ENV_17-00997-CONDIT_03

Application number 17/00997/CONDIT for discharge of Condition 6 concerning drainage for planning permission 15/02107 for the relocation of the Phoenix Gym to land north of Longlea, Fifield Road, Fifield, Berks

Diagram 1

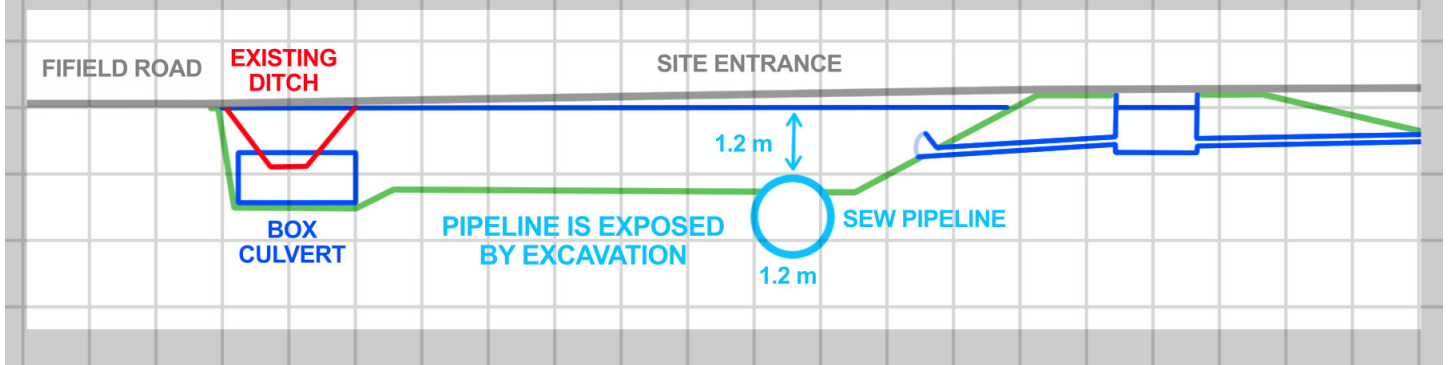
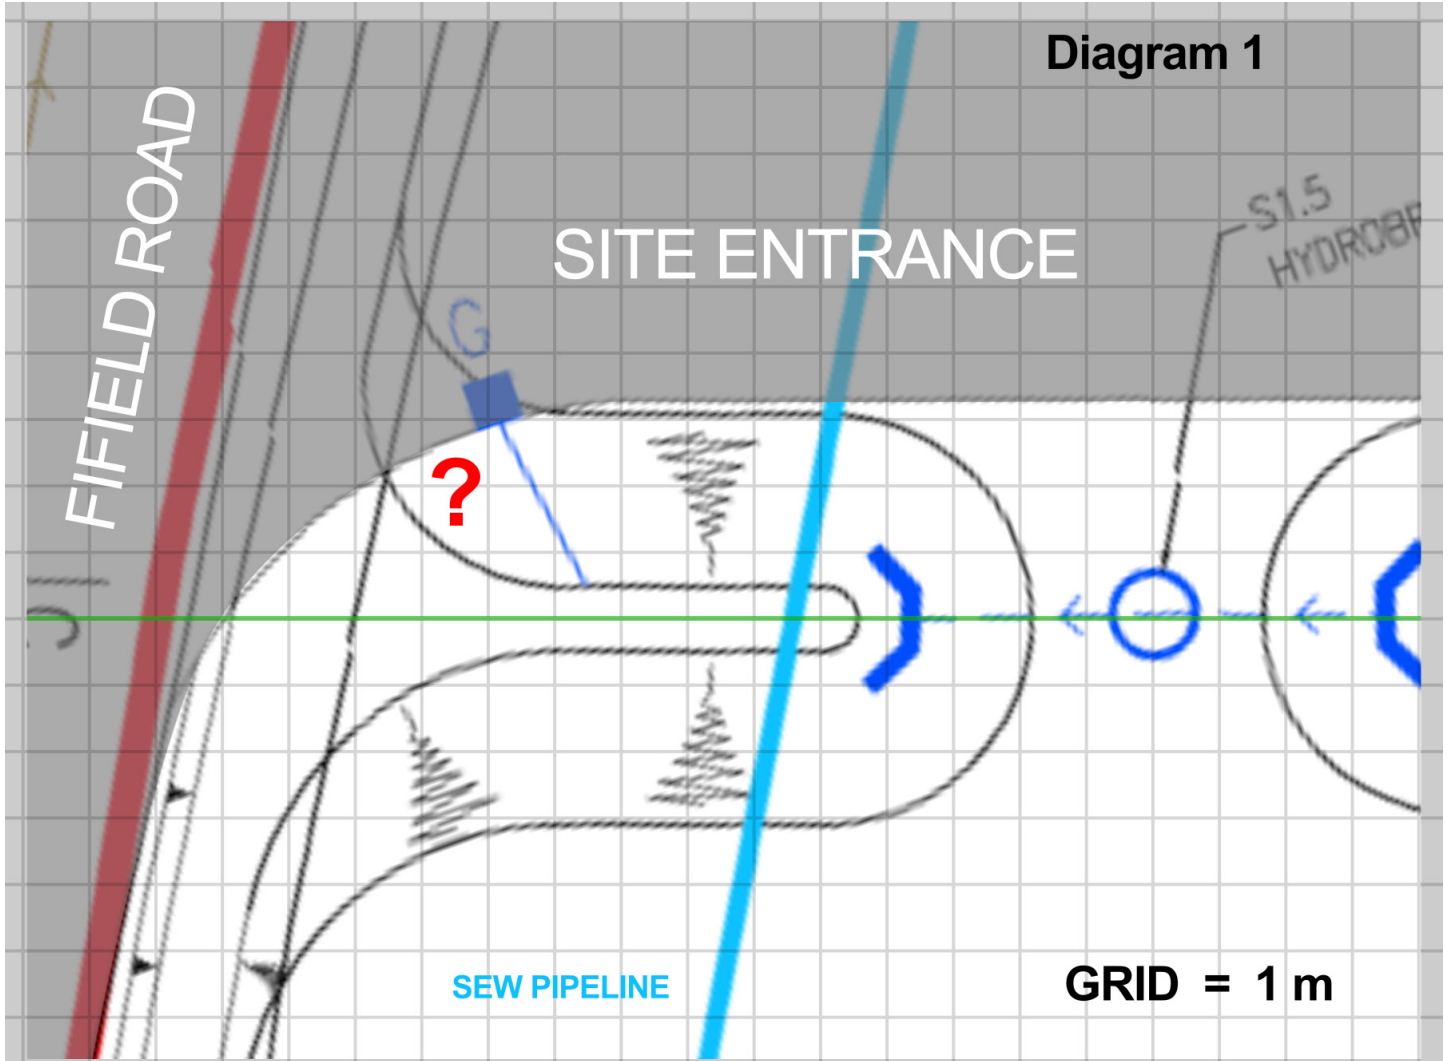
5a - I spent quite a long time studying the new plan detail before coming to the conclusion that it is not possible for this to work in reality. The slopes of the new excavation at the outlet from the site running alongside the entrance road towards the ditch are shown as curving nicely in either direction to blend into the run of the existing ditch. Looks very nice but it then becomes worrying that the site entrance roadway is doing something similar to join the main Fifield Road. But the entrance curve is overlying the ditch curve and in reality it would be impossible to achieve this without some sort of bridge support suspended above the ditch and carrying the roadway clear of whatever is below. It does not look from the drawing as if that really is the intention as there is less than a meter below the road before the top of the box culvert. I can only assume that the box culvert is actually performing the function of "bridge". So if the distance between the bottom of the entrance roadway construction and the top of the box culvert is

actually road base and soil then what is shown on the plan view is actually impossible to achieve.

5b - The box culvert is shown as lying half a meter below the bottom of the existing ditch and the top of the box culvert is shown as barely above the bottom of the existing ditch. So in reality the existing ditch will need to be sloped down an additional half meter on either side to meet the bottom of the box culvert. Prevailing conditions in the existing ditch mean that it won't be long before the lower area is rapidly silting up and will need constant maintenance and cleaning out.

5c - The flap outlet into the new excavation off the existing ditch is shown as being approximately 0.6 m or 0.7 m below the surface. Conditions in most wet seasons mean that this will be under water for long periods of time preventing discharge unless the outflow is pumped under pressure which does not appear to be a suggestion at present.

5d - Are SEW aware that their 1.2 m diameter pipeline whose crown is only 1.2 m below surface will actually be exposed by this excavation ? I know that when we have raised this issue in the past over and over again it has been dismissed by the Applicant and their advisers to be dealt with at some future time and that there are good professional relationships with SEW which mean that it will all get sorted alright in the end. But it can only be considered worrying if drawings are constantly being produced which ignore this reality.
